# Bourne Mill - Phase III

**RIDEM REQUEST FOR PRELIMINARY DETERMINATION SUBMISSION**  
 October 8, 2021

DEPARTMENT OF ENVIRONMENTAL MANAGEMENT  
 OFFICE OF WATER RESOURCES  
 FRESHWATER WETLANDS PROGRAM  
 APPROVED WITH CONDITIONS  
 AS SPECIFIED IN THE LETTER OF APPROVAL  
 DATED DEC - 9 2021 FILE # 21-0211  
 NO CHANGES ALLOWED WITHOUT PRIOR APPROVAL  
 APPROVED PLANS MUST BE AT CONSTRUCTION SITE  
*Mark D. Weneck*

**LANDSCAPE PLAN**

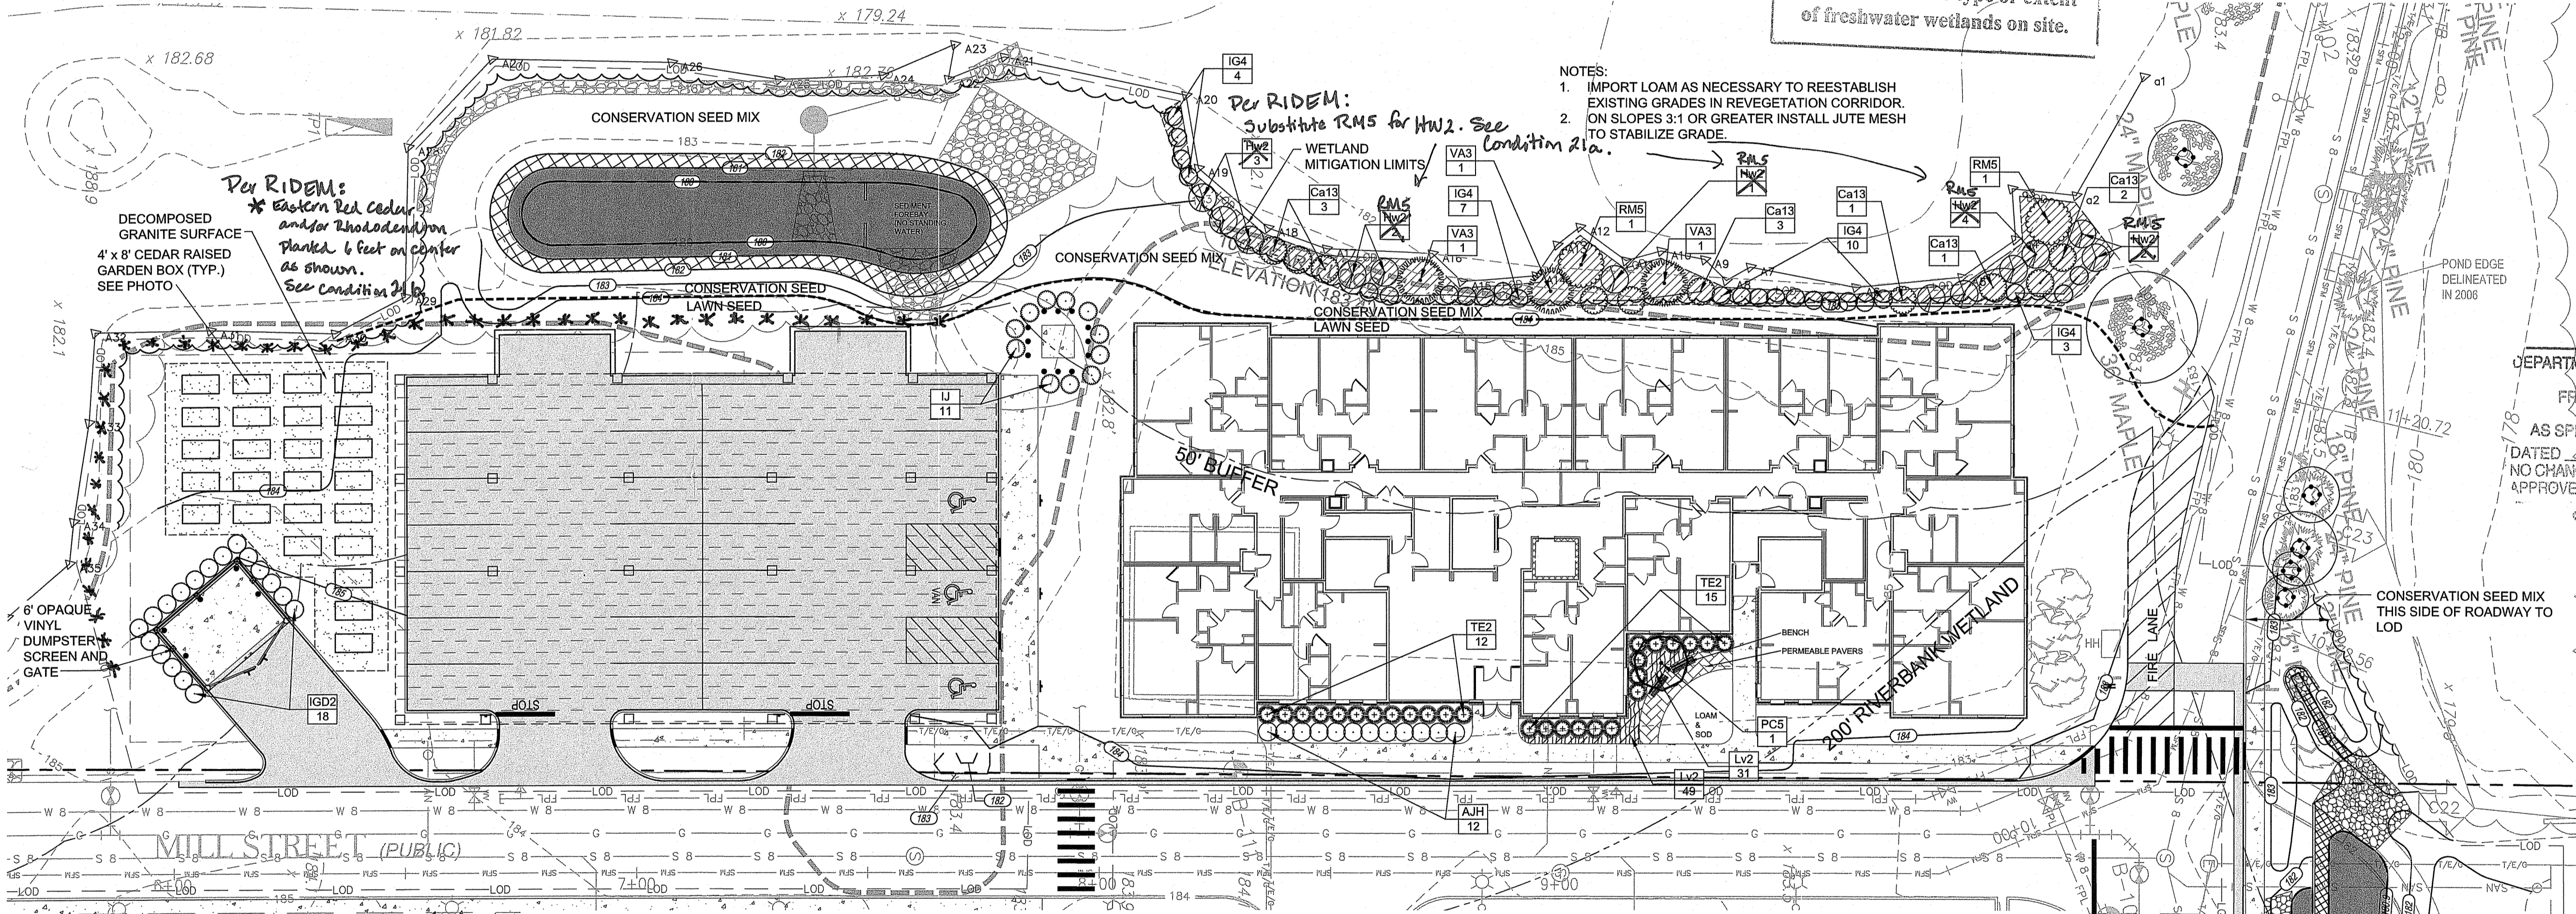
- NOTES:
- IMPORT LOAM AS NECESSARY TO REESTABLISH EXISTING GRADES IN REVEGETATION CORRIDOR. ON SLOPES 3:1 OR GREATER INSTALL JUTE MESH TO STABILIZE GRADE.
  - Per RIDEM: Substitute RMS for HW2. See Condition 21a.
